PREFERRED PROJECT REPORT
MP 10_0171

330 CHURCH STREET, PARRAMATTA

JULY 2012

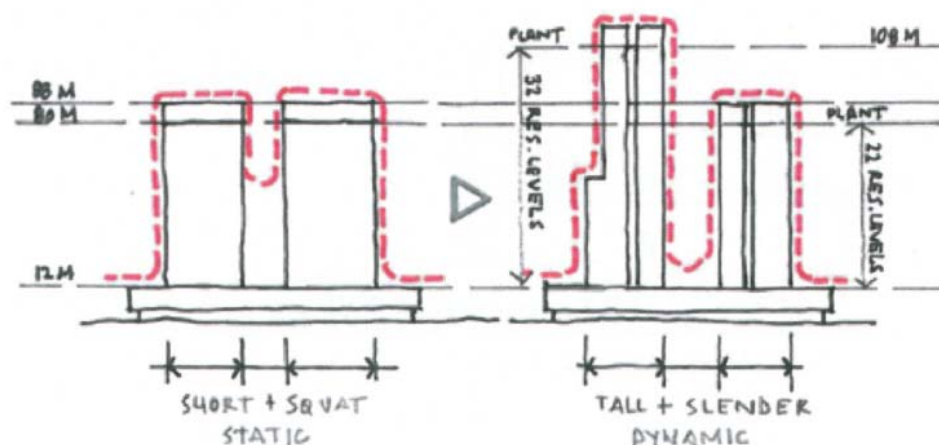
The Council submission states that the proposed eastern tower is 29.6 metres higher than the LEP height controls and the winning design competition entry.

Tower	LEP Height Limit	Proposed Height	Compliance
East	88 metres (including 10% design competition bonus)	84.5 metres	Yes
West	88 metres (including 10% design competition bonus)	117.6 metres	No

Given the findings of the above table, it is assumed that Council meant to refer to the proposed western tower – not the eastern tower.

The eastern tower complies with the height limit. The western tower seeks a 29.6-metre variation to the maximum height limit.
